<b>Applicant:</b>	J&B Builders, Inc.
<b>Property Owner:</b>	J&B Builders, Inc.
<b>Location:</b>	NE corner of S. 1 <sup>st</sup> & Prairie Streets
<b>Purpose:</b>	Feedback on a mixed-use building
<b>Application:</b>	Concept Plan
<b>Public Hearing:</b>	Not required
<b>Zoning:</b>	CBD-1 / PUD
<b>Current Land Use:</b>	Vacant
<b>Comprehensive Plan:</b>	Mixed Use

**Milestone Row 2**

<b>Summary of Proposal:</b>	<p>J&amp;B Builders, Inc. has filed a Concept Plan proposing a mixed-use building on the remaining vacant lot in the Brownstone PUD. Details:</p> <ul style="list-style-type: none"> <li>• 50 ft., four-story building fronting S 1<sup>st</sup> St. <ul style="list-style-type: none"> <li>○ Floor 1 – commercial space &amp; parking</li> <li>○ Floors 2-4 – up to 20 condo units</li> </ul> </li> <li>• 44 interior parking spaces for building residents, accessed from Cobblestone Dr.</li> <li>• 15 on-street parking spaces along 1<sup>st</sup> St.</li> </ul>
<b>Info / Procedure on Application:</b>	<ul style="list-style-type: none"> <li>• Per Sec. 17.04.140, the purpose of the Concept Plan review is as follows: “to enable the applicant to obtain informal input from the Plan Commission and Counc

**SITE PLAN**

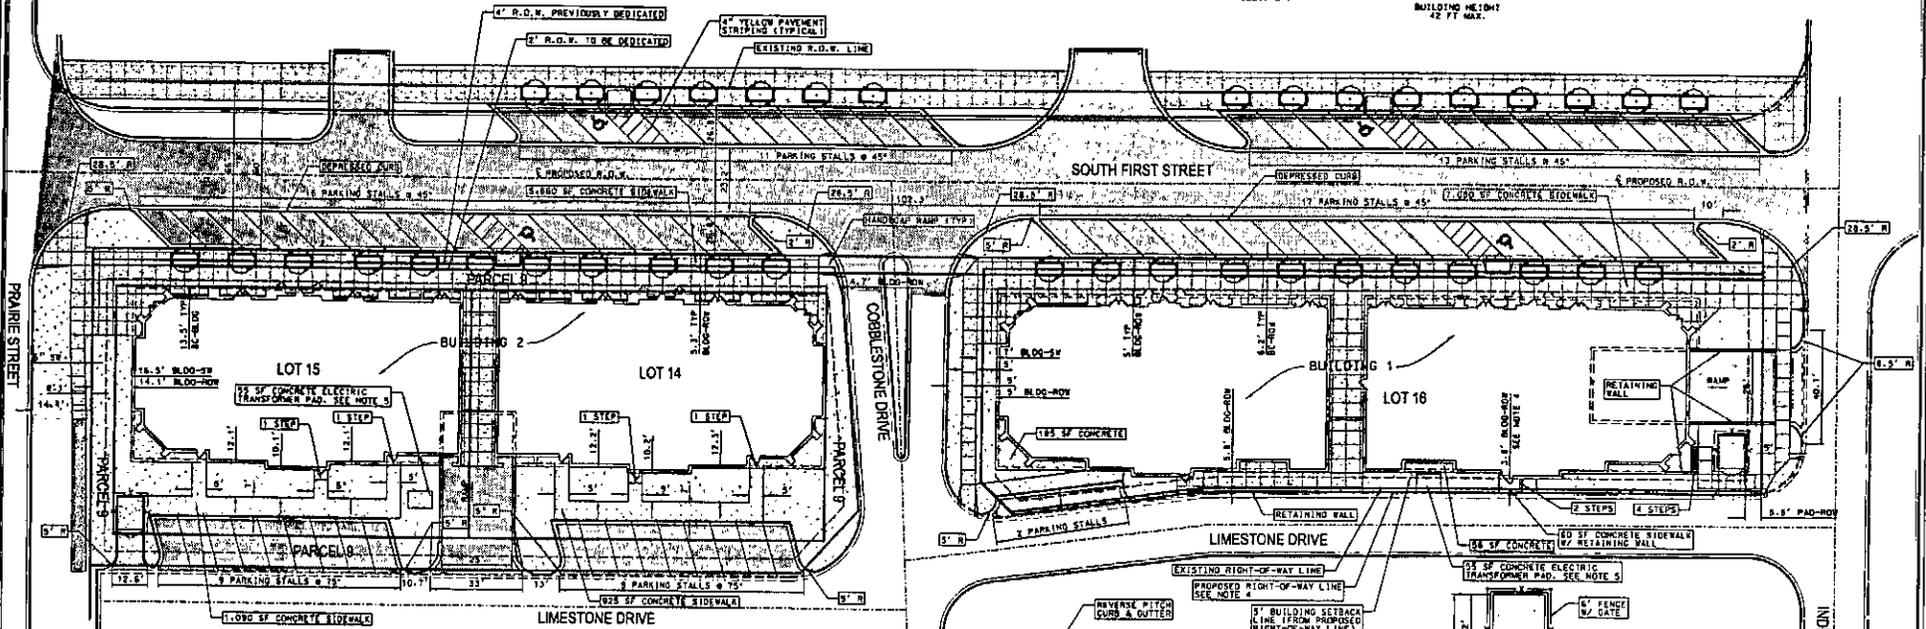
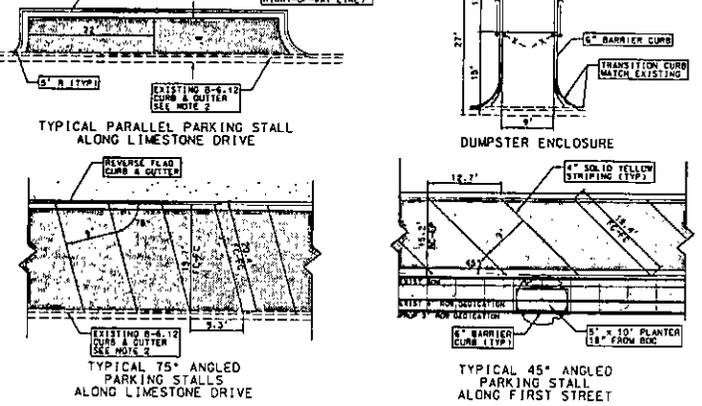
- ✓ The 2005 approved plan included a total of 34 exterior spaces (along 1<sup>st</sup> St. and behind building) vs. 20 exterior spaces proposed. This change reflects the reduction of commercial space, from about 16,000 sf approved to just 3,600 sf now proposed.

OUTLINE OF  
MILBSTONE 1

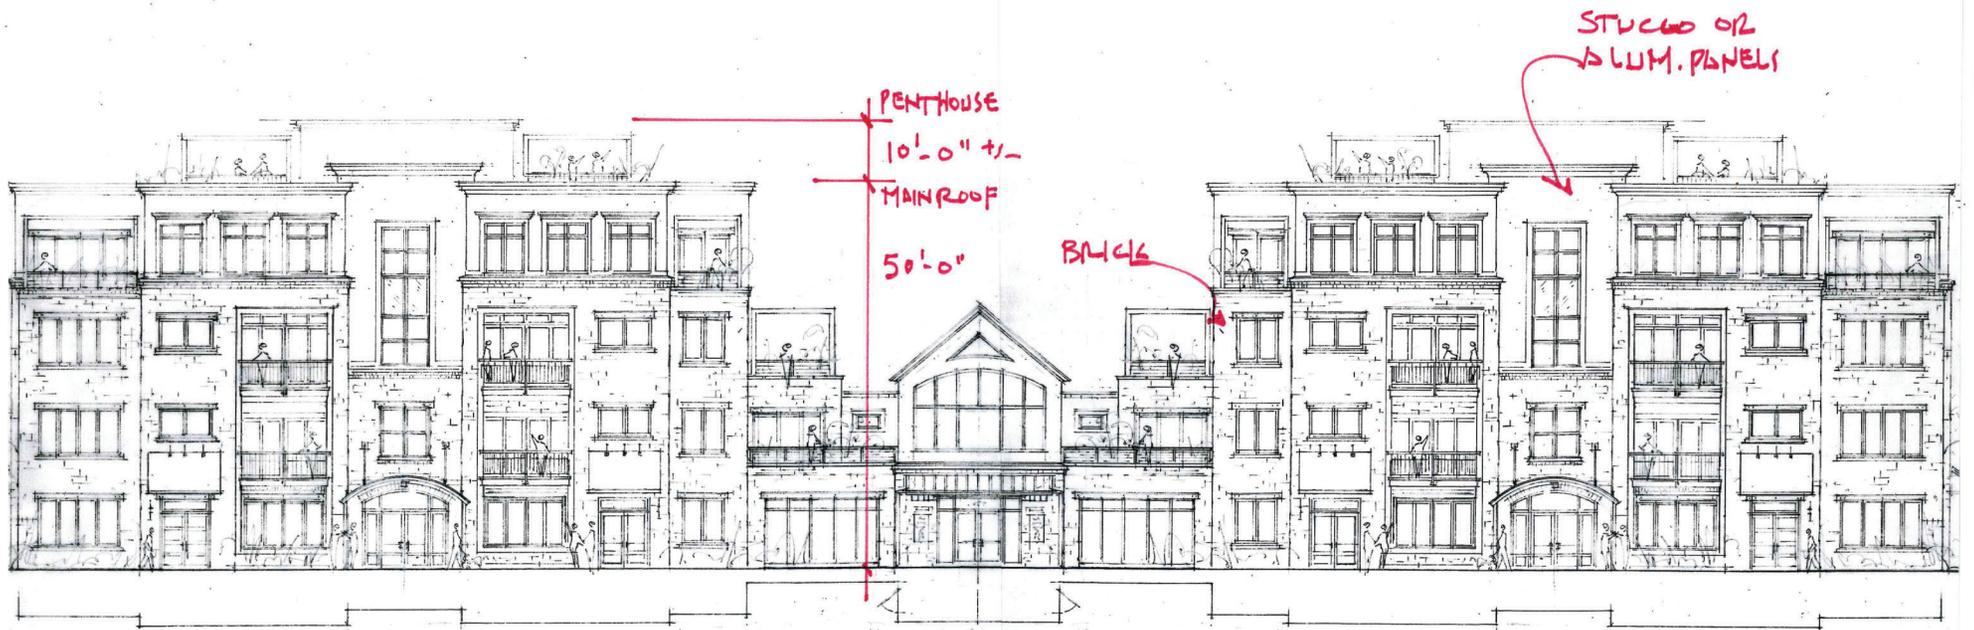
- Building mass split by a two-story central section instead of a one-story breezeway (see exhibit showing proposed building overlaid with the Milestone Row building outline).
- Larger building footprint (22,705 sf vs. 16,000 sf).
- Parking for residents on the ground-level instead of underground.
- Less Commercial space (limited to western portion of first floor instead of the entire first floor.)
- Fewer parking spaces behind the building along Limestone Dr. (5 vs. 18 parking spaces planned, due to larger building footprint)
- Curb cut for resident parking access off Cobblestone Dr. (north end) instead of Limestone Dr. (rear/east side).
- More modern architectural style.

- ✓ The proposed building has a larger footprint than the approved building (22,702 sf proposed vs. approx. 15,000 sf planned). However, while the approved building was four full stories, the central portion of the proposed building is only two stories and contains parking for a majority of the first floor. This results in an overall gross floor area that is only about 2,500 sf larger than the approved building.
